MEMORANDUM

DATE:	July 26, 2021	RWDI REFERENCE #: 1904405
TO:	Angela Kavanagh	Email: angela.kavanagh@mirvac.com
FROM:	Kevin Peddie	Email: kevin.peddie@rwdi.com
	Michael Pieterse	michael.pieterse@rwdi.com
RE:	Solar Access – Comparison of DA Scheme and Proposed Design Changes Waterloo Metro Quarter – Building 2

Southeast Apartments

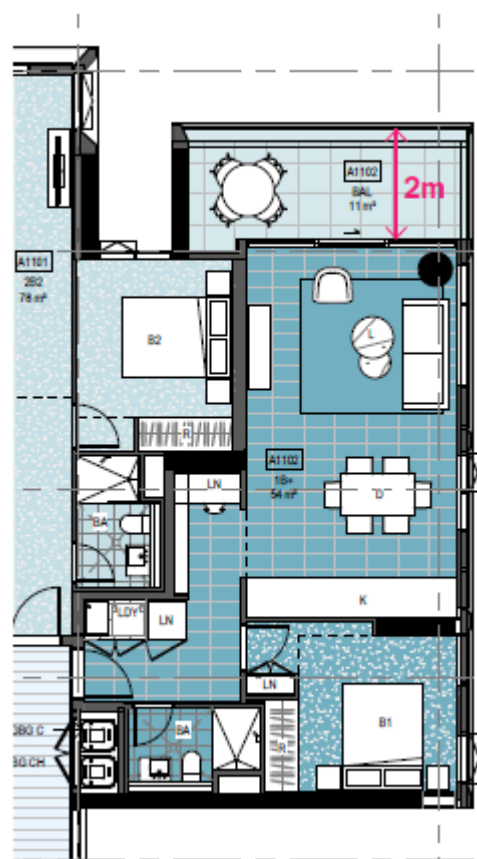
With consideration for the limitations of overshadowing to Alexandria Park as well as required balcony depths, the balustrade and glazing line of the southeast apartment on Levels 3 to 21 has shifted to the east, while the southeast column has been relocated to be within the apartment. These changes can be noted in the below comparative plans.

- With the adjustments in the glazing and balustrade, solar access to 1m² to the living room glazing was predicted to improve by 10 minutes compared to the DA Scheme. The area of sunlight which lands on the glazing surface has also increased as noted in the following table.
- The living room windows are now predicted to receive more than 1 m² of direct sunlight for 1 hour and 40 minutes between 9:00 am and 10:40 am on the winter solstice.

East High-Rise Apartments

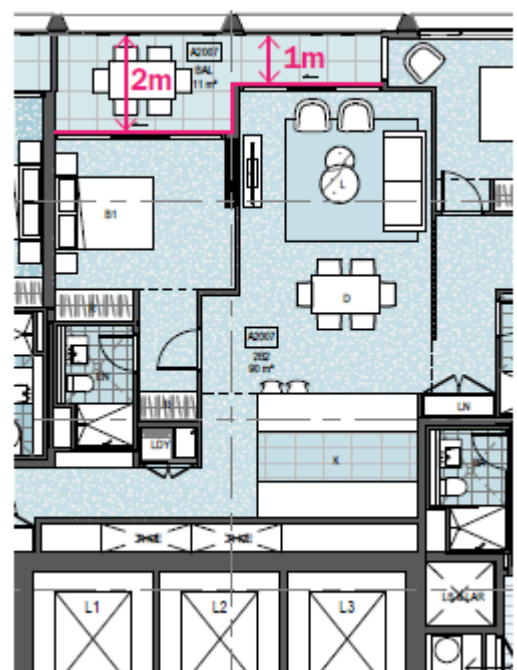
The living room glazing of the units on Levels 20 and 21 has shifted 1 m east in this reconfiguration as shown in the below comparative plans.

- In the DA Scheme, the POS of the east-facing 2-bedroom apartments on Levels 20 and 21 were predicted to comply with ADG solar access requirement while the living room was predicted to achieve 1 m² of direct sunlight for 1 hour and 20 minutes between 9:00 am and 10:20 am on the winter solstice.
- With the living room glazing shifted east by 1m, the living room windows were predicted to receive more than 1 m² of direct sunlight for 2 hours between 9:00 am and 11:00 am on the winter solstice.

West Apartments

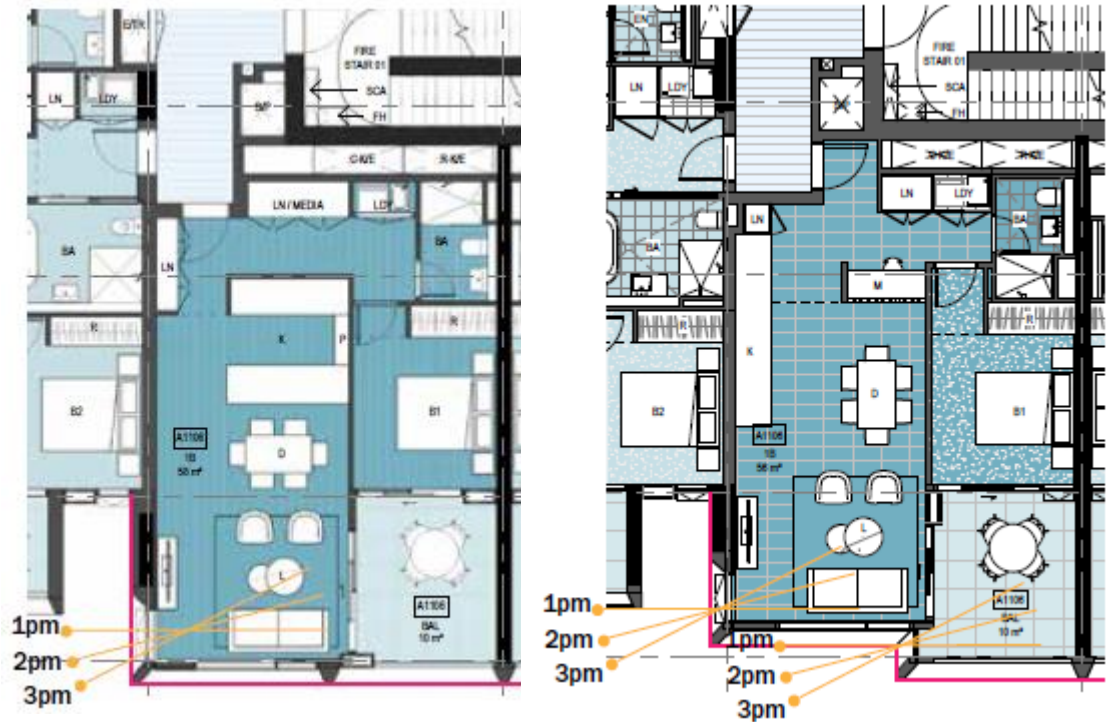
The living room façade on Levels 3 to 19 has shifted 700 mm east in this re-configuration to provide an opportunity for the northern sun to penetrate into the POS as indicated below.

- In the DA Scheme, the living room of the west-facing 1-bedroom apartment was predicted to comply with ADG solar access requirement while the POS was predicted to achieve 1 m² of direct sunlight for 10 minutes between 2:50 pm and 3:00 pm on the winter solstice.
- With the proposed design change, the living room and POS were both predicted to achieve 1 m² of solar access for 1 hour and 50 minutes on the winter solstice. This was a balance between solar access to both areas. The POS will also now receive direct sunlight for more than 2hrs, while direct sunlight was only achieved in the DA Scheme from 1:45pm.
- It is noted that the reduction in massing of Building 1 of the development increases the number of floors to which there is any area of solar access at 1:00 pm by two.

West High-Rise Apartments

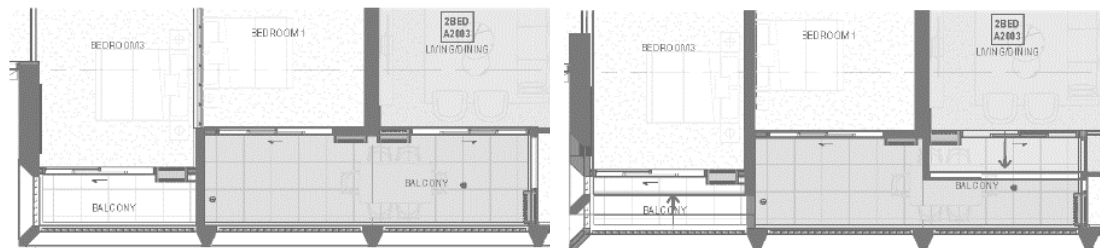
The changes to the west high-rise units on levels 20 and 21 mirror those of the east high-rise units with a shift of the living room glazing by 1 m to the west as indicated in the comparative plans below.

- In the previous scheme, the living room of the high-rise west apartment was predicted to achieve 1 m² of direct sunlight for 15 minutes between 2:45 pm and 3:00 pm on the winter solstice, while the POS was predicted for 1 hour and 5 minutes between 1:55 pm and 3:00 pm (for unit 2003).
- With the proposed design change, taking unit 2003 as an example, the living room and POS were predicted to achieve 1 m² of solar access for increased time periods of 50 minutes and 1 hour and 50 minutes respectively. Level 21 achieves slightly more sunlight due to the increased floor to floor height as well as there being no levels above which overshadow.
